MEMORANDUM

July 2, 2014

TO: Landmarks Board

SUBJECT: Public hearing and consideration of an application for a Landmark Alteration Certificate to construct a 925 sq. ft., one-story, four-car garage at the northeast corner of the property at 1507 Pine Street, an individually landmarked property, per section 9-11-18 of the Boulder Revised Code 1981 (HIS2013-00219).

Figure 13: Proposed Site Plan

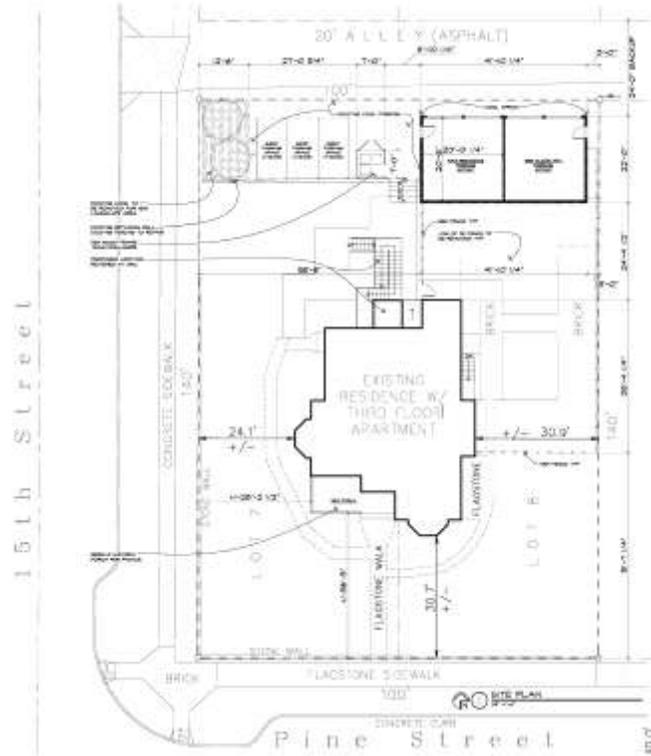
A 925 sq. ft., one-story garage is proposed at the northeast corner of the lot. The garage is to measure 22' by 41'10" and is accessed off the alley on the north side. The building is to measure 12' to the top of the parapet. The interior head height would measure 9'.

8.3 Mechanical and Utility Facilities			
	Guideline	Analysis	Meets Guideline?
.5	<i>Minimize the visual impacts of trash storage and service areas by screening them from the street.</i>	Trash enclosure (7'x7'x6') proposed at west side of proposed garage. Details should be reviewed by the Ldrc.	Maybe

Figure 14: Proposed North Elevation (façade)

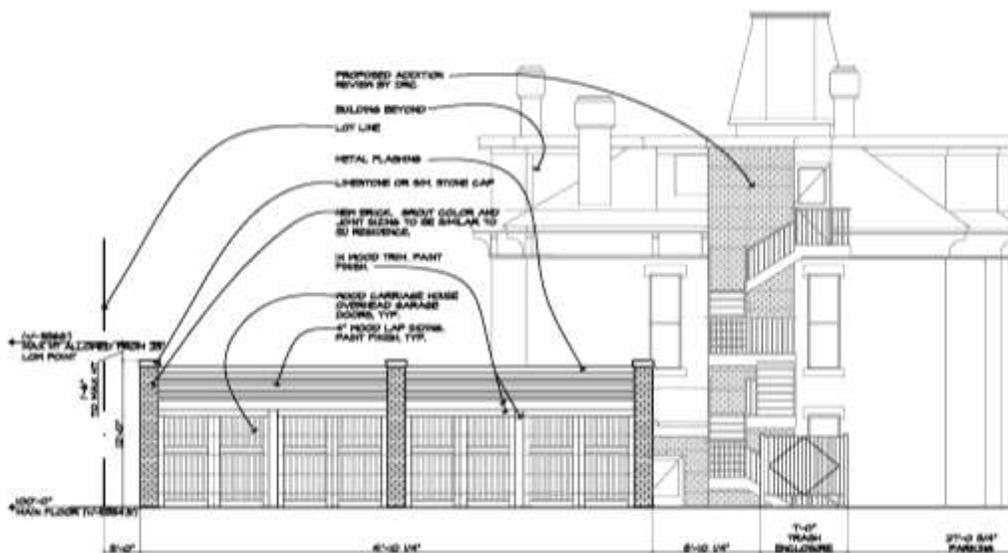
The north elevation, facing the garage, is shown to have two carriage-style overhead doors. Brick piers are to be located on the ends and in the middle. The parapet above the garage doors would be clad in 4 inch wood lap siding.

Figure 15: Proposed West Elevation

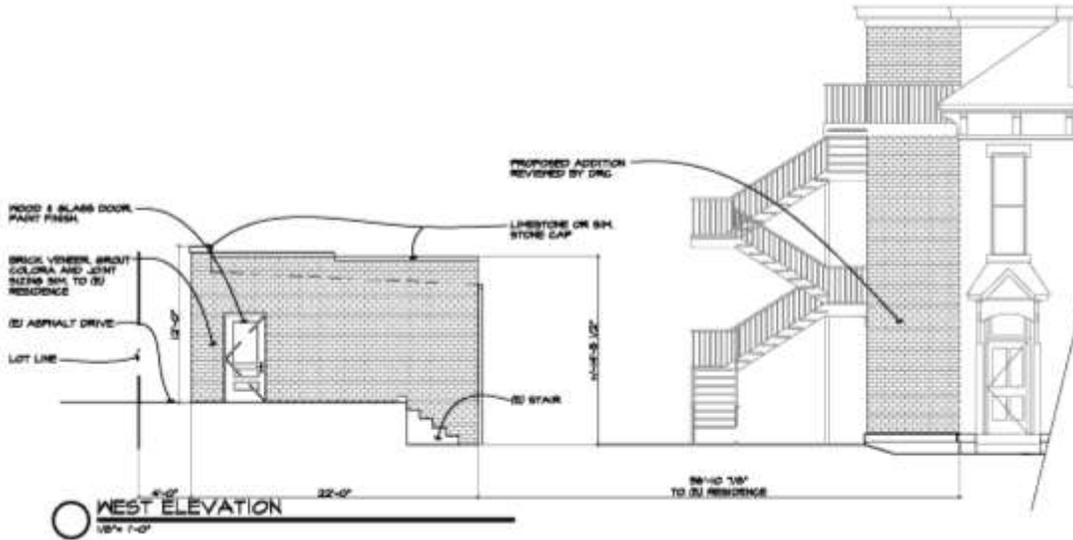
The west elevation, facing 15th St., is shown to be simply detailed, with a half-light wood pedestrian door and stairs from the existing raised parking area to the lawn below.

Figure 16: Proposed South Elevation

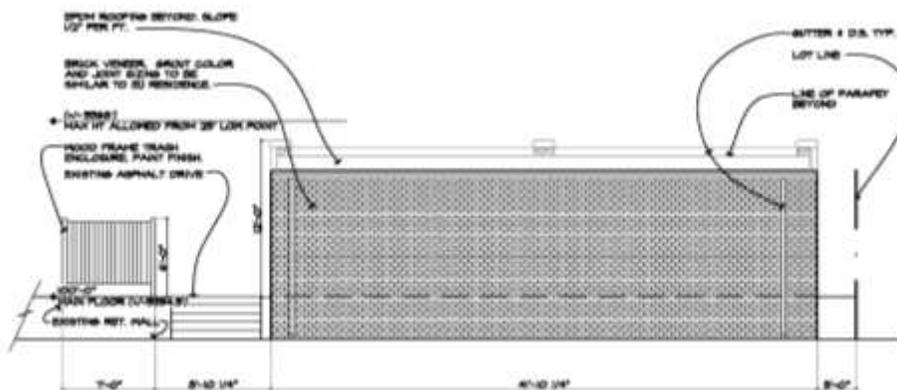
The south elevation, facing the interior of the lot, does not feature any fenestration or ornamental detailing.

Figure 17: Proposed East Elevation

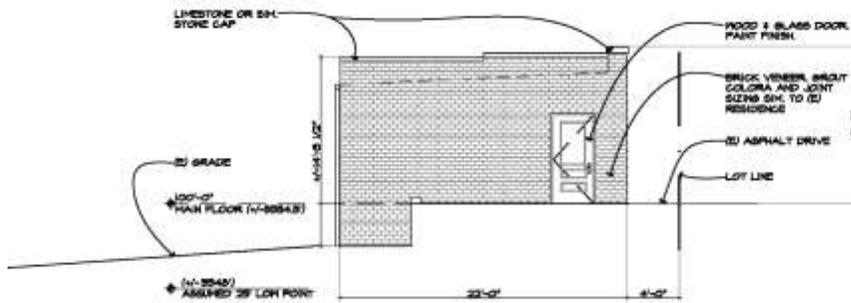
The east elevation mirrors the west elevation, and is shown to be simply detailed, with a half-light wood pedestrian door.
